PLANNING & ZONING COMMISSION MEETING

Tuesday, March 25, 2025 at 6:00 PM

Re: Liquor Store Conditional Use Request
Gluckstadt Rd.
Gluckstadt, Ms

Re: Gluckstadt Road Liquor Store Building

1 SITE PLAN
 A1.0
 SCALE: 1"=30'-0"

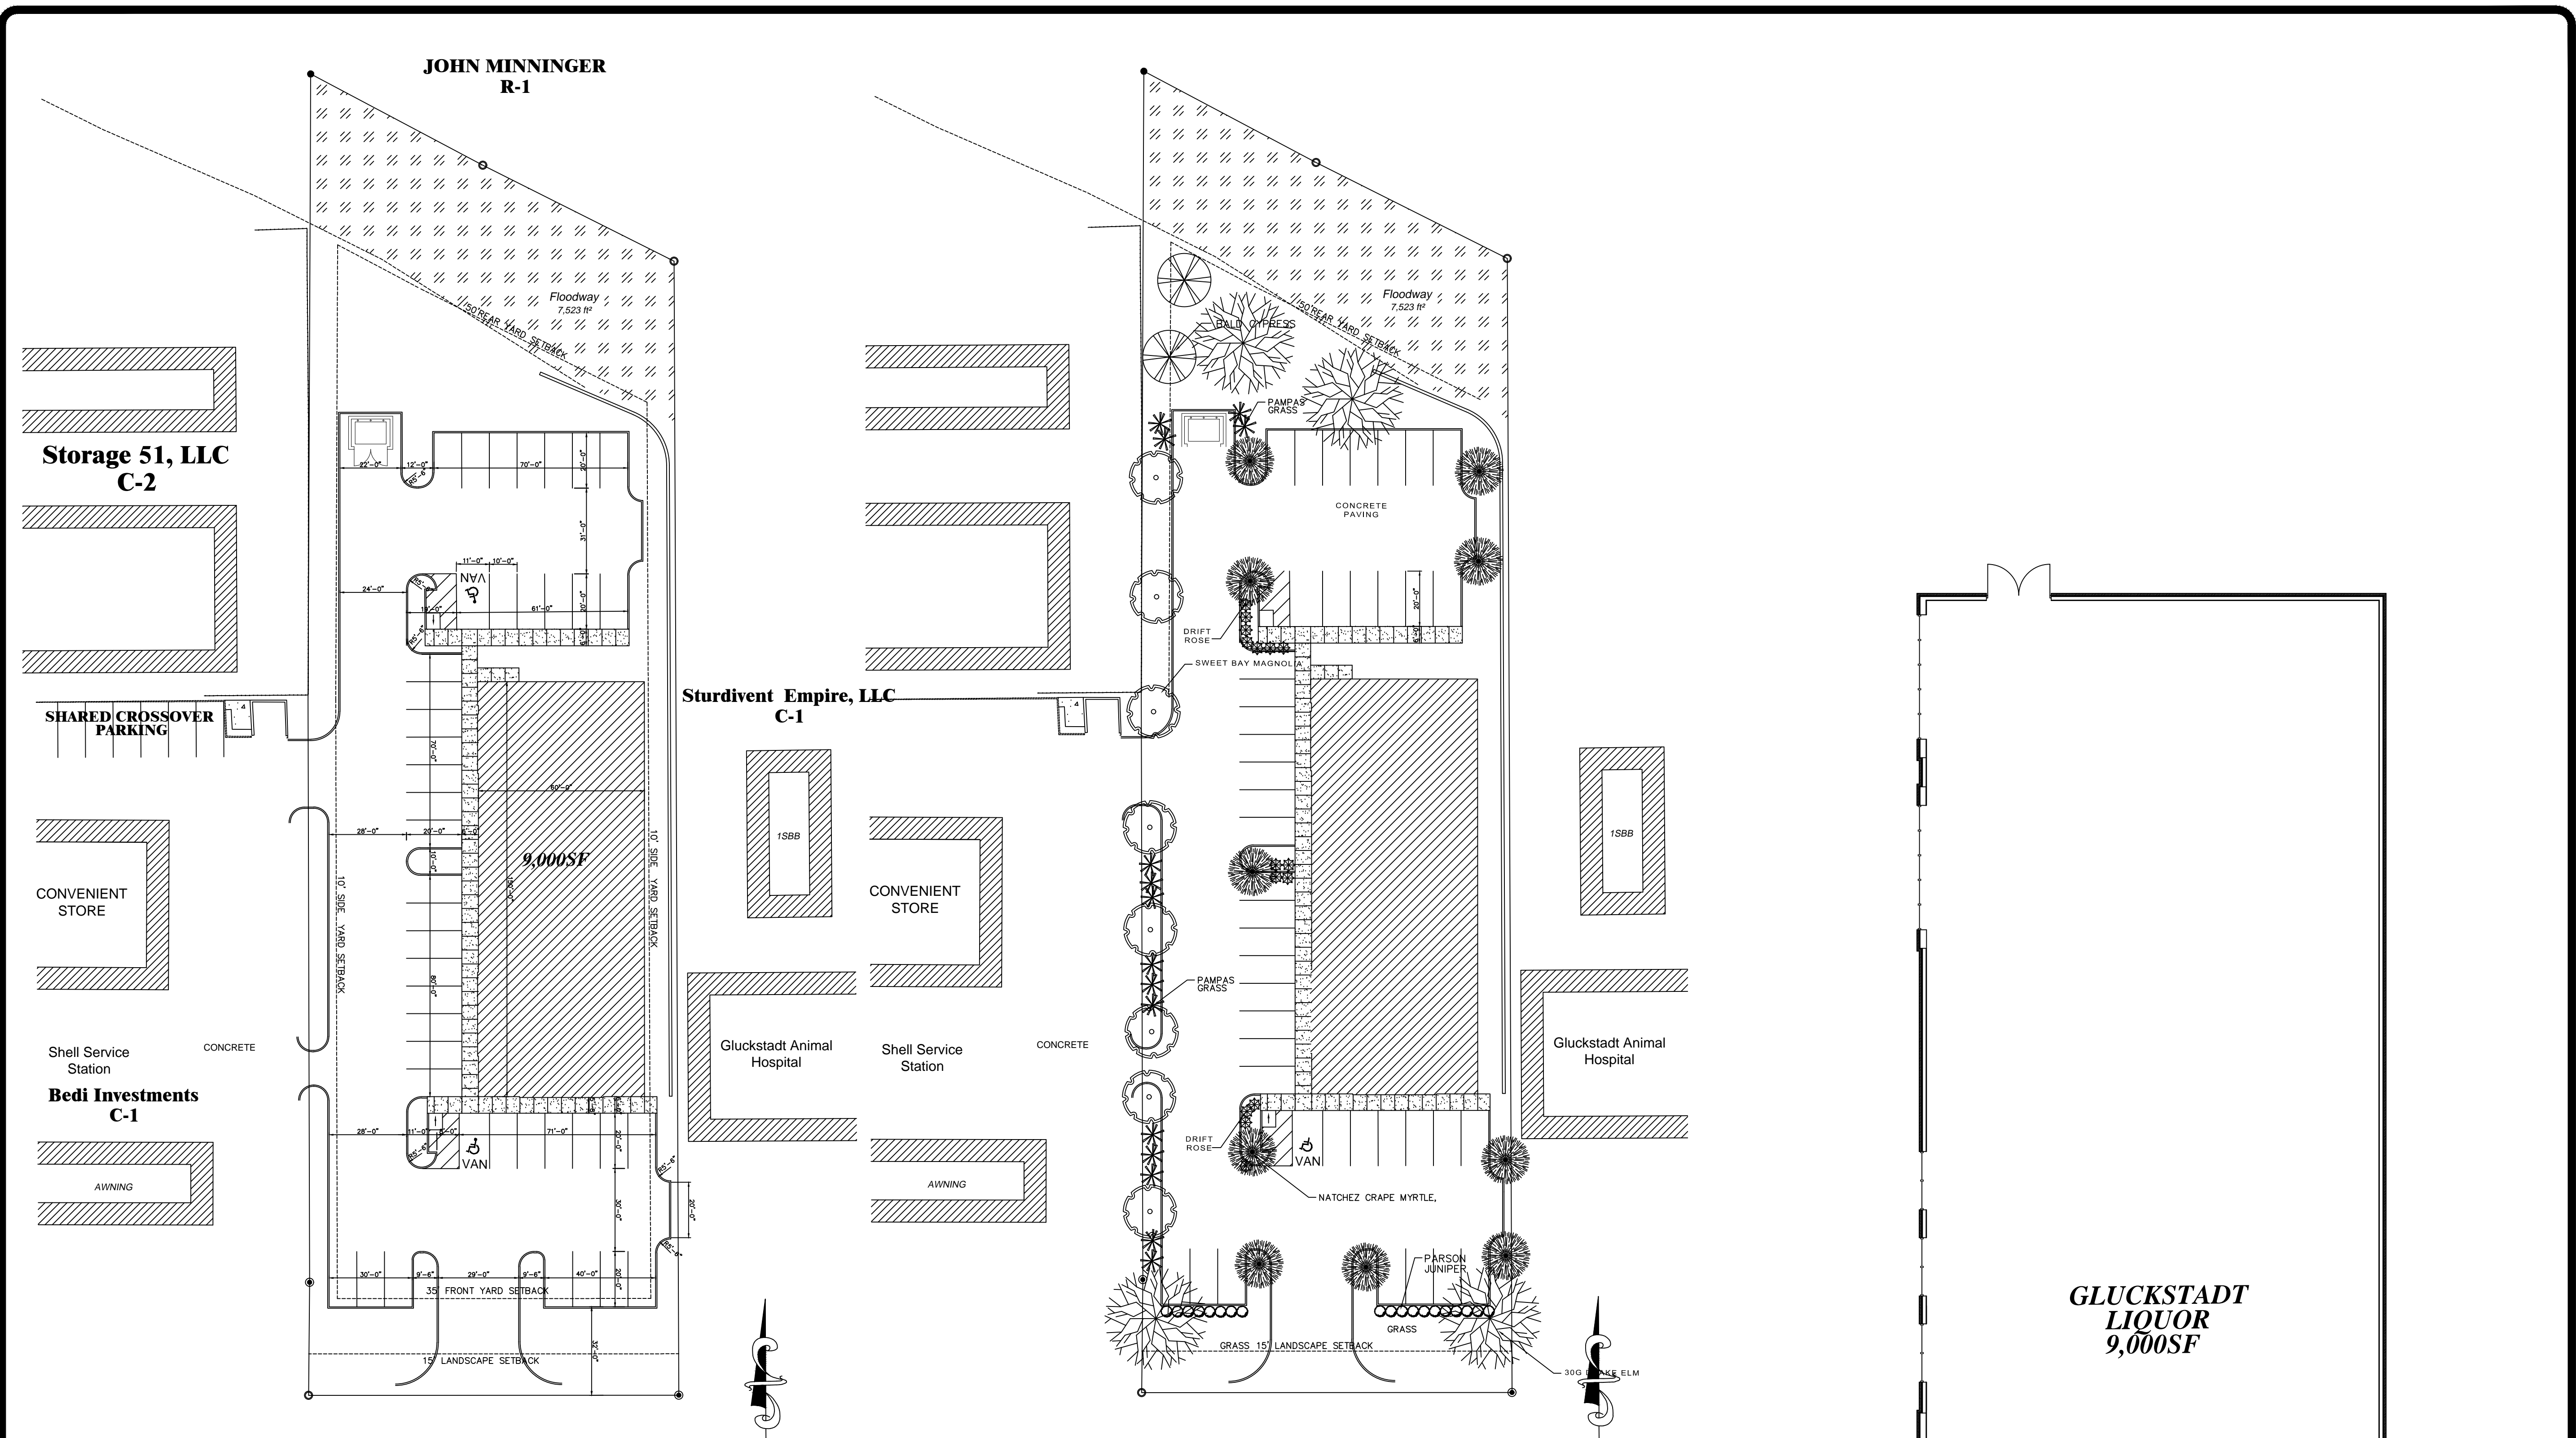
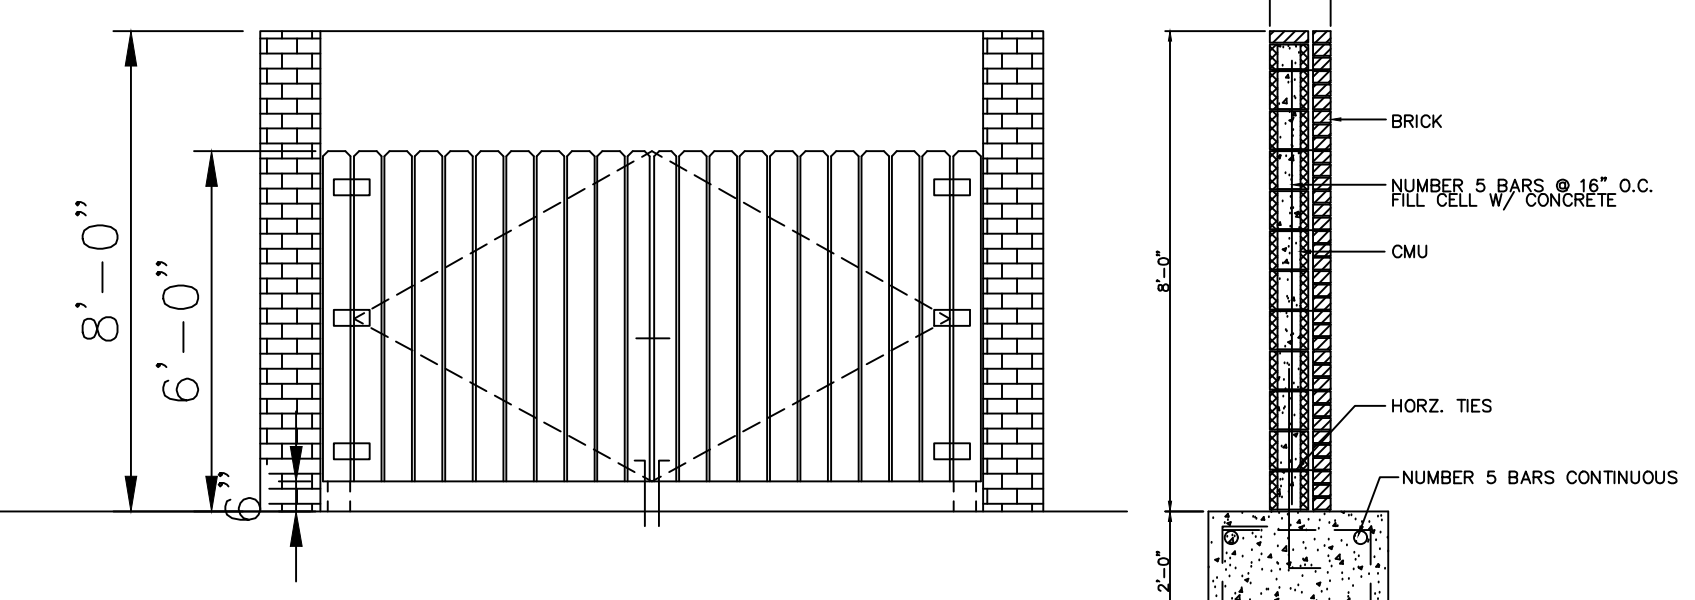
3. There are insufficient parking spaces as designed. 50 are needed and only 45 provided. Please note there is a current project underway to widen Gluckstadt Rd. It is currently in the design phase and it is not known at this time if it will impact the space available at the street frontage side of the lot for parking. Please coordinate with the Public Works Department for information regarding that project.

4. Per the Landscape Ordinance; Trees shall be required at the minimum rate of one (1) natural shade tree for every ten parking spaces. The parking rows shall begin and terminate with a landscape island and no more than fifteen (15) parking spaces shall be permitted in a continuous row without being interrupted by a landscape island. Landscape islands shall be a minimum 200 sq. ft.

ZONING C2
BUILDING USAGE = RETAIL
TOTAL SITE = 58,709SF
BUILDING SF = 9,000SF
LOT COVERAGE = 15%
REQUIRED PARKING
9,000SF / 225 = 40 SPACES
PROVIDED PARKING = 43 SPACES

UNDERGROUND STORAGE

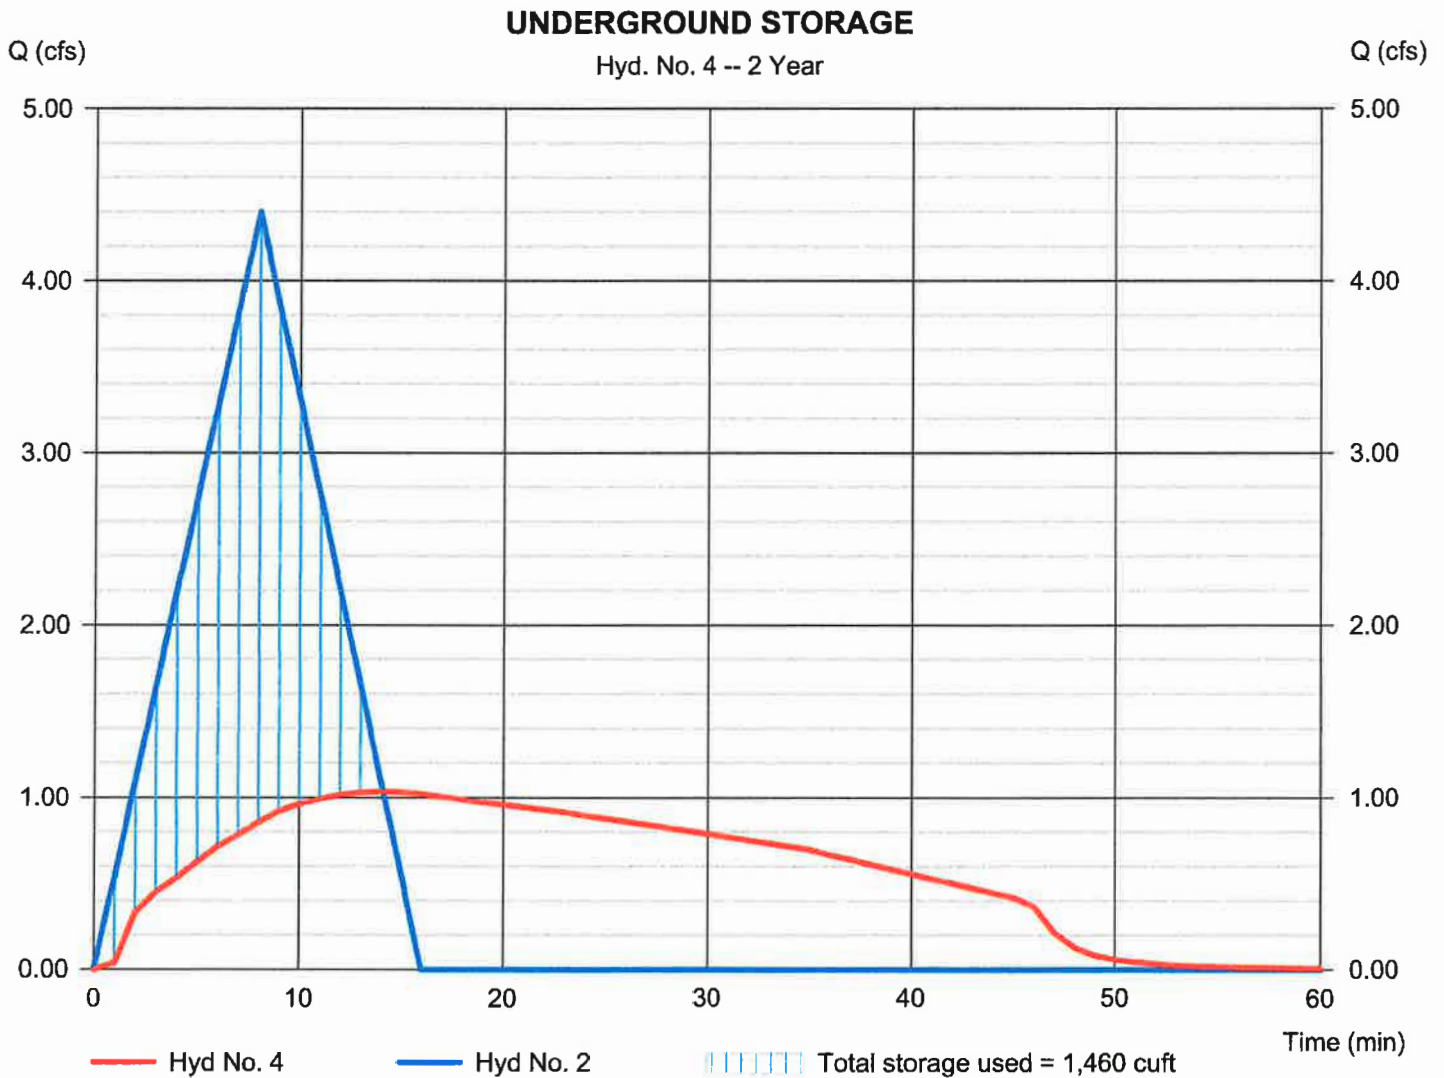
1) Please provide detailed hydraulic/hydrologic calculations. The provided table does not show time of concentration, intensity reference, etc.

2) Detention is to be provided by the 48" storm drain system. Please provide calculations showing that the 48" pipes will provide sufficient volume to detain the additional runoff created by the development.

Information is provided in stormwater calculations PDF. PDF was modified to include requested information.

Information is provided in stormwater calculations PDF.
